GROUP 54

CHASSIS ELECTRICAL

OUTLINE OF CHANGES

Code No.32 IG signal circuit system	Probable cause
The ignition switch signal is not being input to the immobilizer-ECU.	• Malfunction of wiring harness or connector • Malfunction of the Ignition switch • Malfunction of the immobilizer-ECU

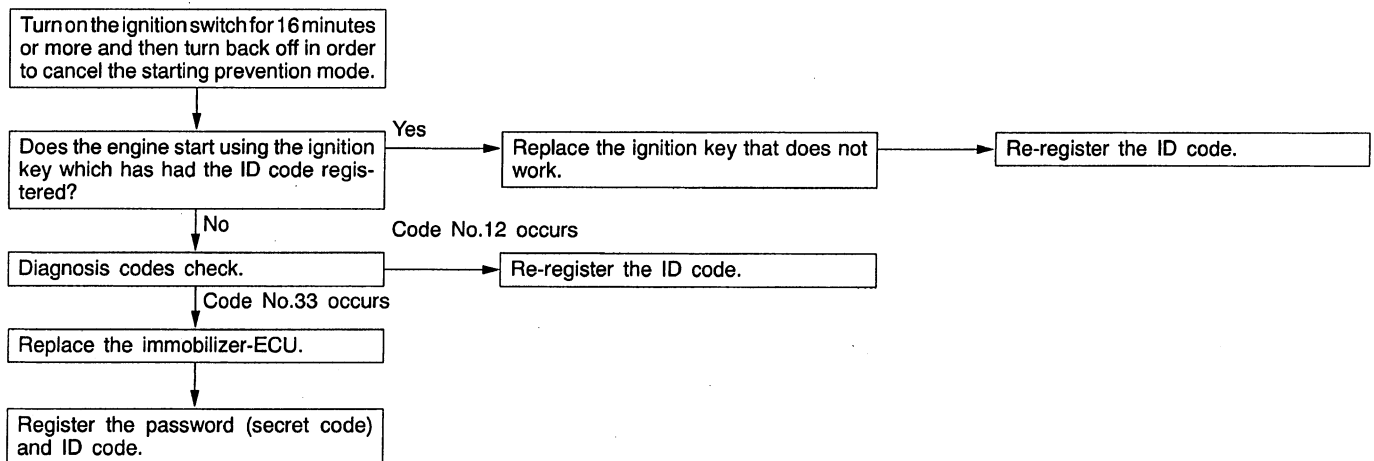
- The troubleshooting procedures have been changed to correspond to the change of the immobilizer-ECU.
- The service procedures have been established to correspond to the change of the rear fog lamp switch.
- The service procedures have been established to correspond to the adoption of the rear window defogger timer.

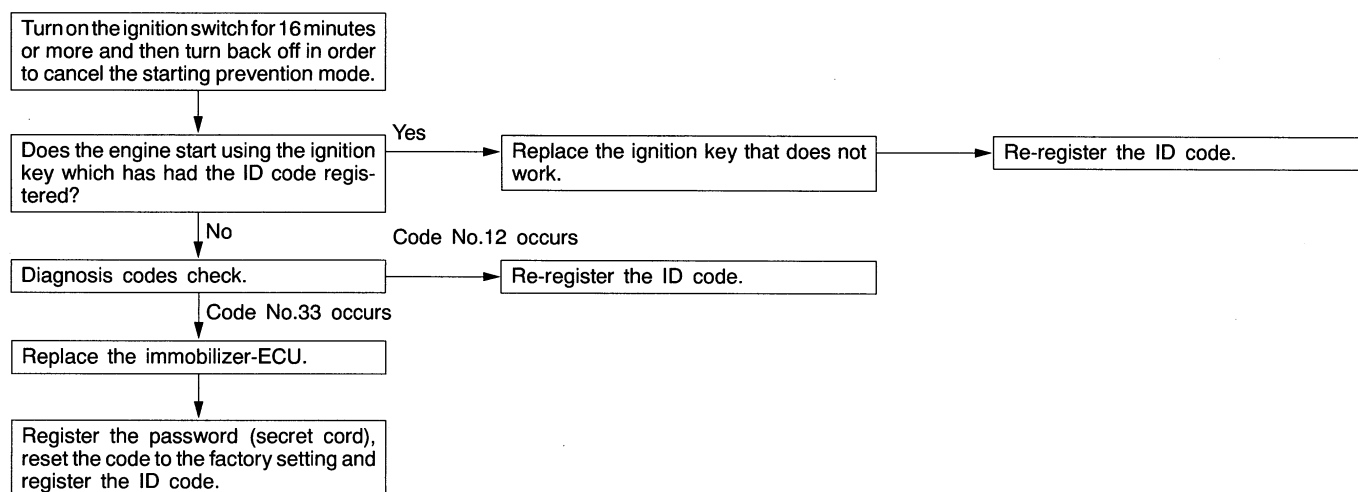
Code No.33 Starting prevention mode activated due to incorrect operation	Probable cause
The ID codes do not match for a total of 5 continuous operations.	• The ID code in the ignition key being used has not been properly registered. • Malfunction of the immobilizer-ECU • Malfunction of the transponder
